INDESIT company

WITXL129EU

F050760

1140960 Exploded views

WIRING P = DRUM BLOCK COD. C00141995

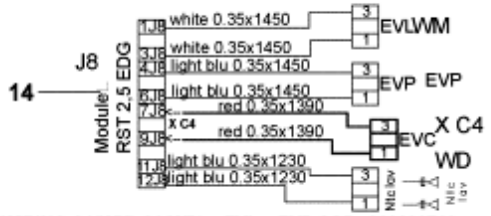
The new wiring when fitted, must be securely attacched to the machine wiring with insulating tape. **Matr. 61116.0001**

n4008f00: Thermic link wire removed on three-phase motor

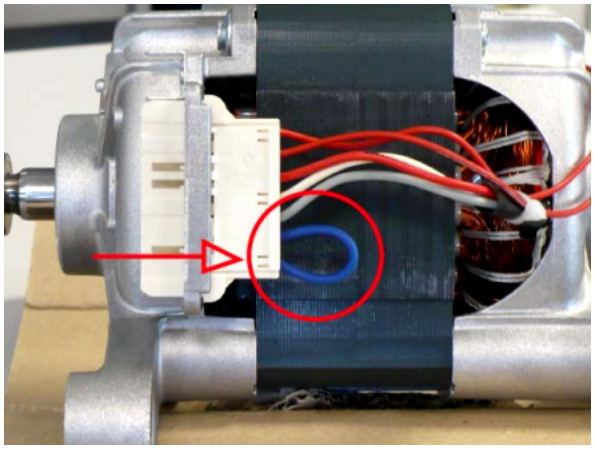
Attention!

When you assist the premodification models using the new motor code you MUST use the thermic link wire code C00265838.

The spare part warehouses will manage the premodification motor until the end of the stock, after they will be replaced with new ones and thermic link wire.

TRIPHASE P32 46 L TOP LOADING
C00265832 new motor without thermic link wire - C00262375 premodification motor with thermic link wire

In the attached image you can see the fixing of thermic link wire in the motor therminal box.
